MEMORANDUM

Subject: SLUP 25-03 – 4515 Chamblee Dunwoody Road, Parcel ID # 18 345 10 023

REQUEST

Aerial Map

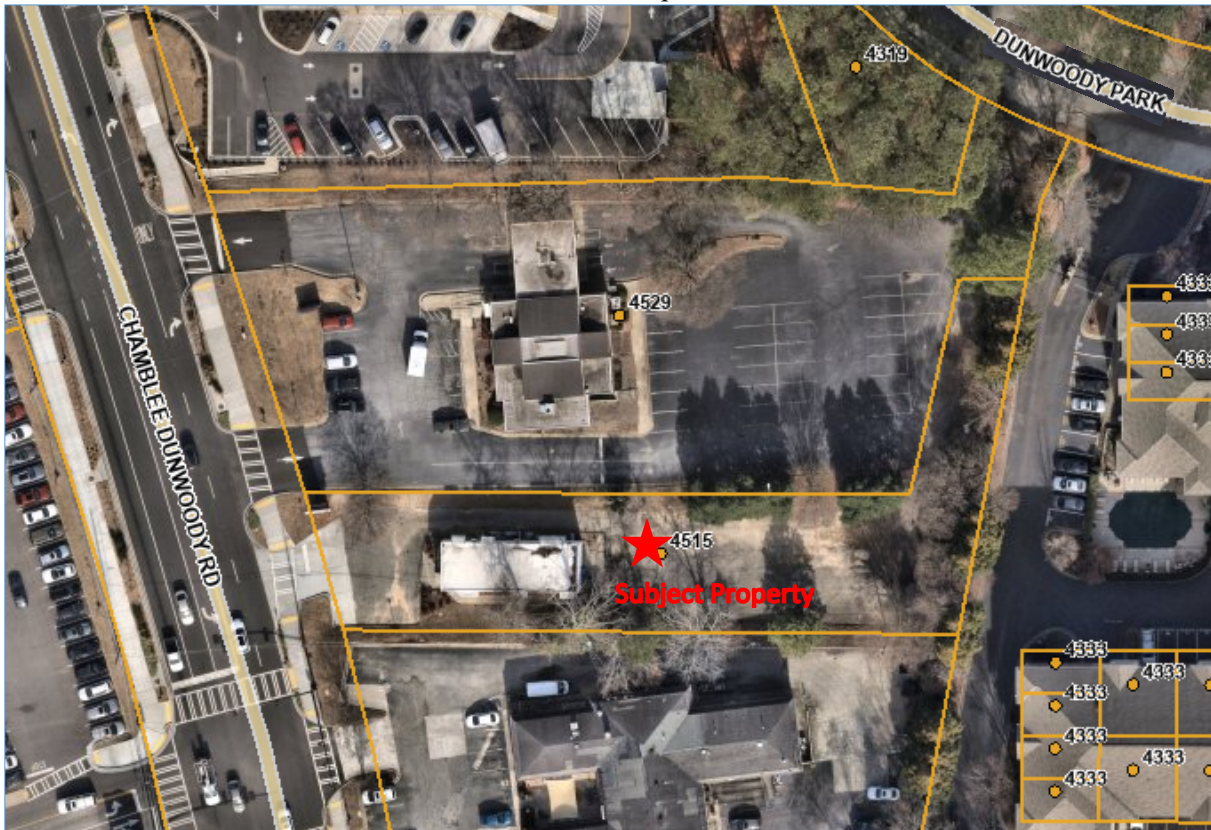
The subject property, 4515 Chamblee Dunwoody Road, is 0.49 acres and is zoned C-1 (Local Commercial). The Georgetown shopping center is located across the street to the west, a Truist Bank branch is located to the north, the Terraces of Dunwoody condominiums are located to the east, and there is small another shopping center to the south. There is one building currently on the subject property – it was previously used as a hair salon and an insurance agency but is currently vacant.

The main vehicular access to the site is via the entrance on Chamblee Dunwoody Road. The applicant also proposes to use an existing driveway connection to Dunwoody Park at the rear of the property to have a second point of ingress and egress. For arterial streets with a speed limit of 35 mph (such as Chamblee Dunwoody Road), the minimum distance between vehicular access points is 245 feet per the City’s land development regulations. The existing ingress/egress on Chamblee Dunwoody Road does not meet this requirement from either the Truist Bank entrance to the north, which is approximately 26 feet away, or the shopping center entrance to the south, which approximately 58 feet away. Driveways in close proximity are considered unsafe due to the increase in the number of conflict points, especially on busy and high-speed streets. Chamblee Dunwoody Road is on the City’s High Injury Network and is listed in the City’s Road Safety Plan as a priority street. Staff therefore recommends that the access on Chamblee Dunwoody Road be right-in, right-out only for access management and traffic safety purposes.
